Re: The Residences at Stone Ridge - Phase II

Response to CEI Peer Review Comments

SMMA No. 19162

FIG. 2.1

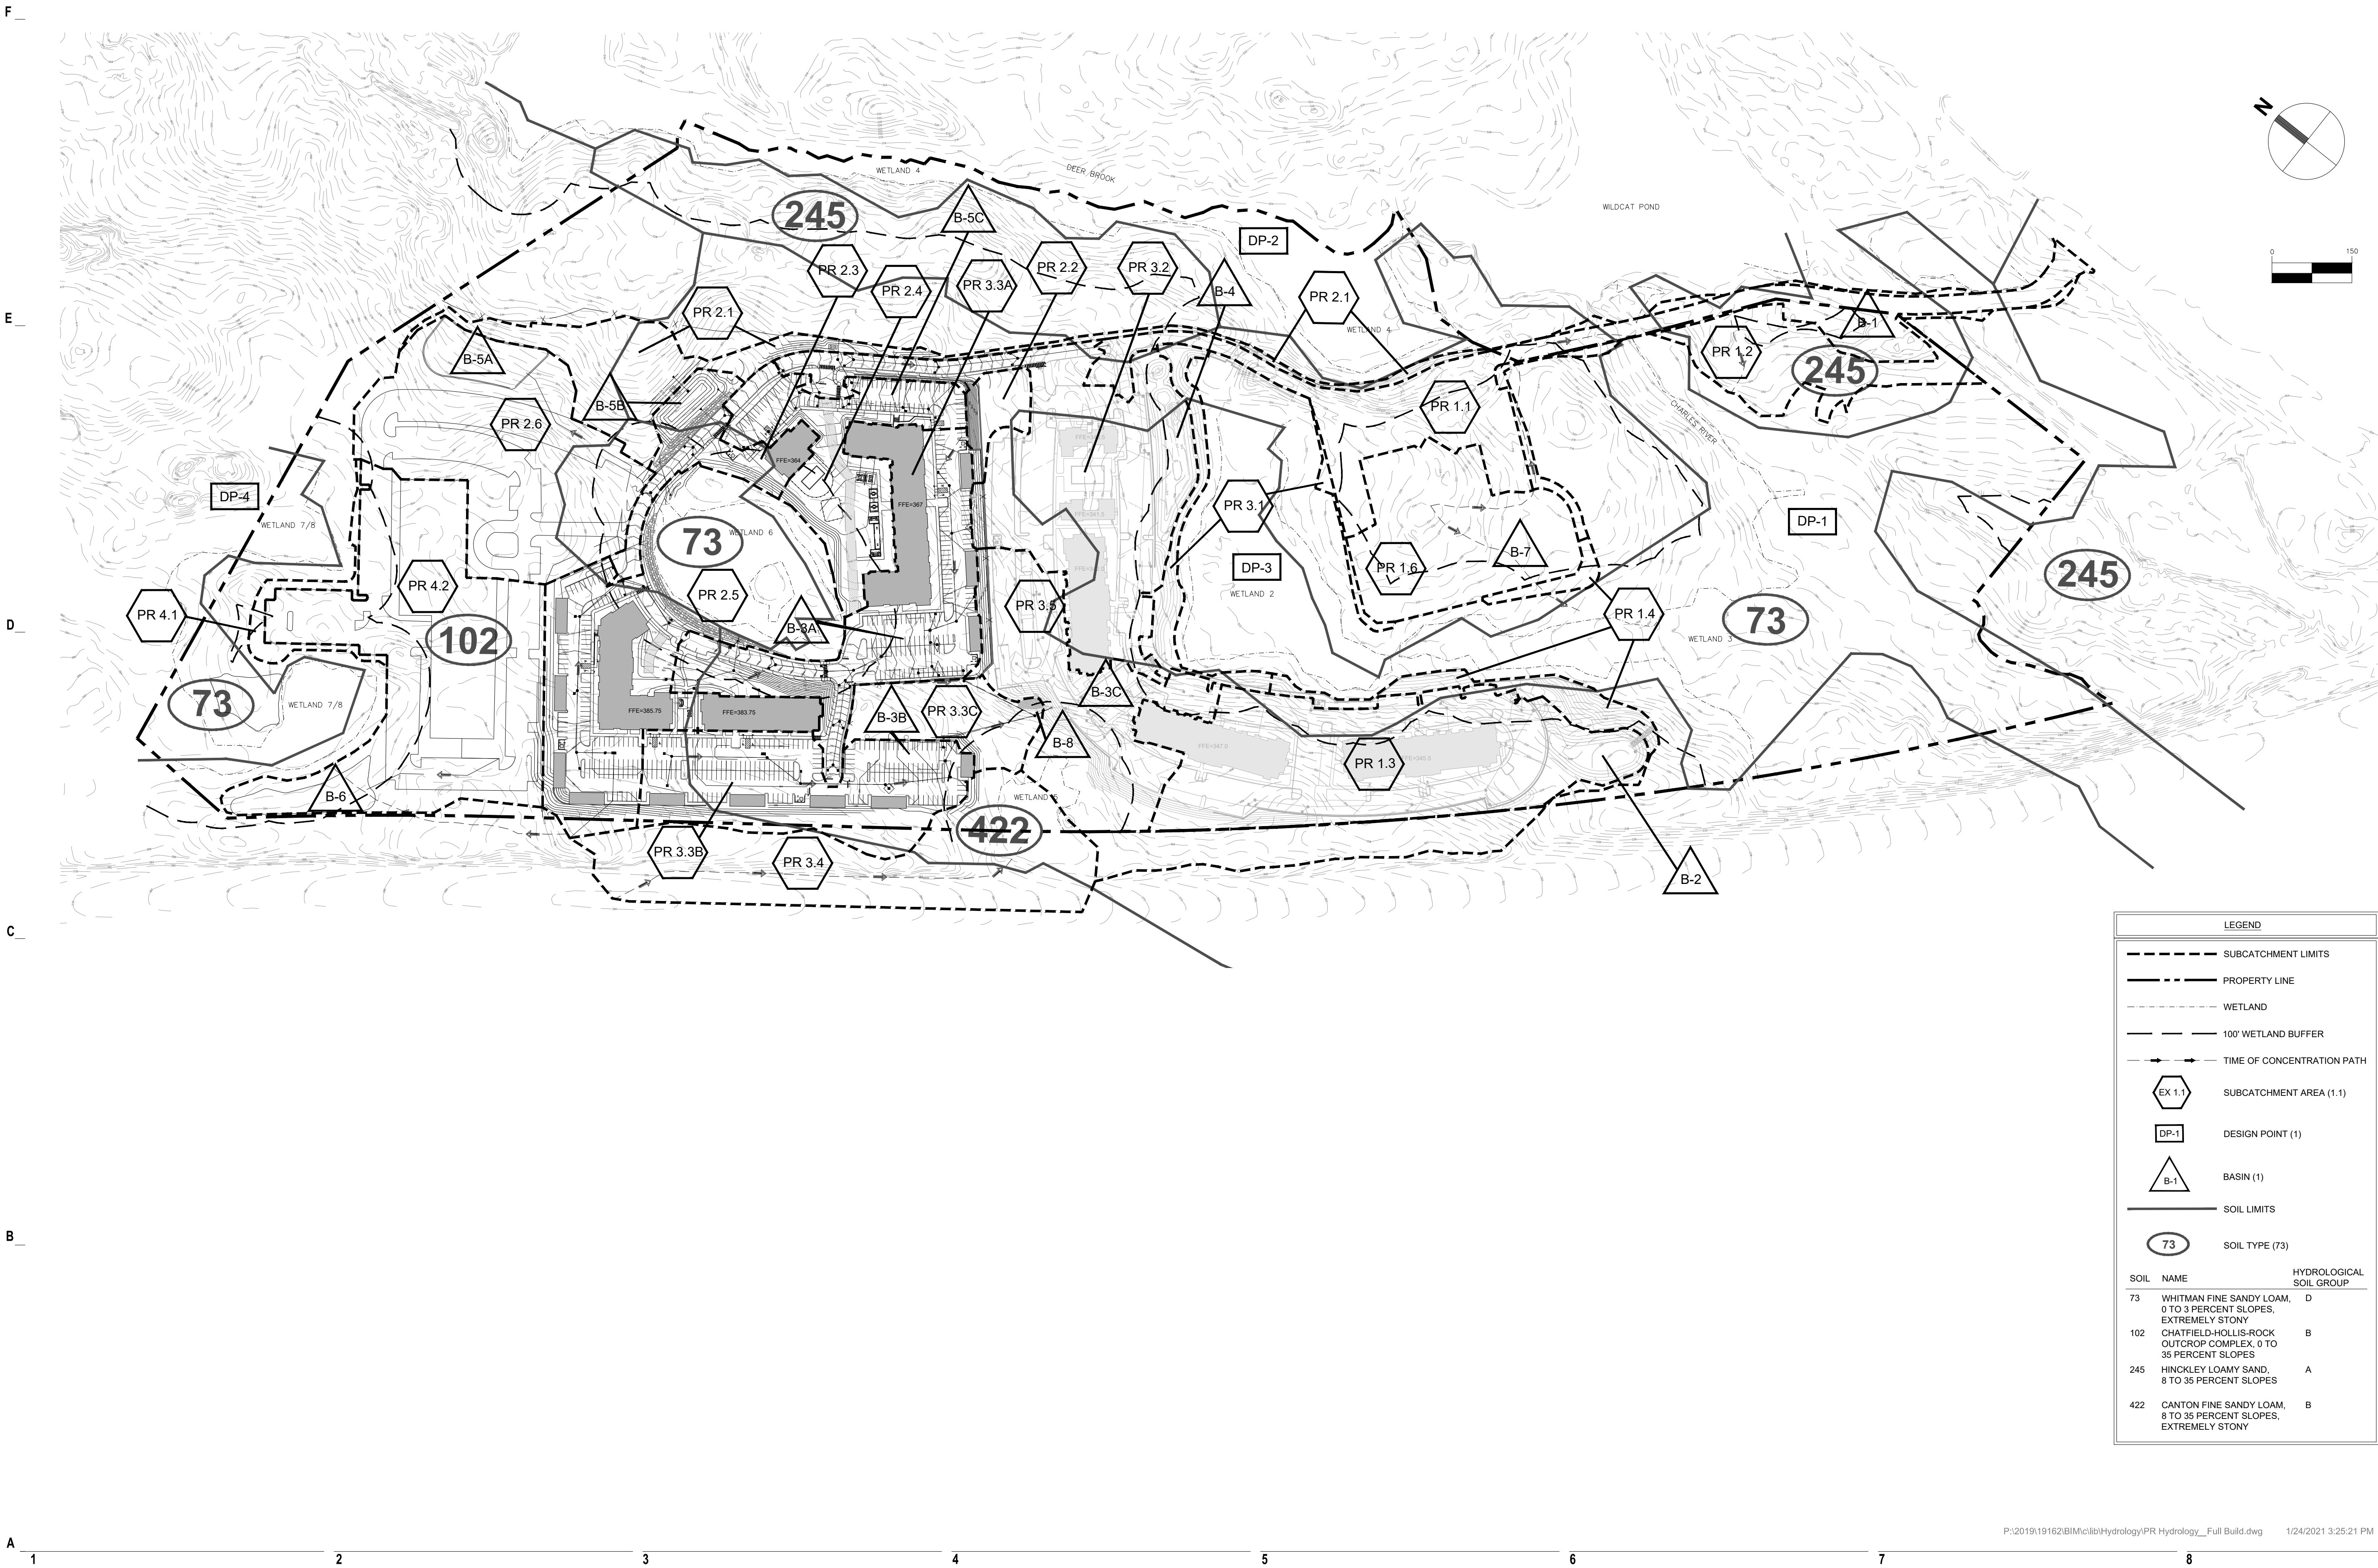
CEI stated it appears that proposed peak rates do not exceed existing peak rates, but has requested a drainage map with closer scale for review.

R. Concur. Refer to attached Existing and Proposed Drainage Areas exhibits plotted at Arch D 24x36 and 1"=150' scale.
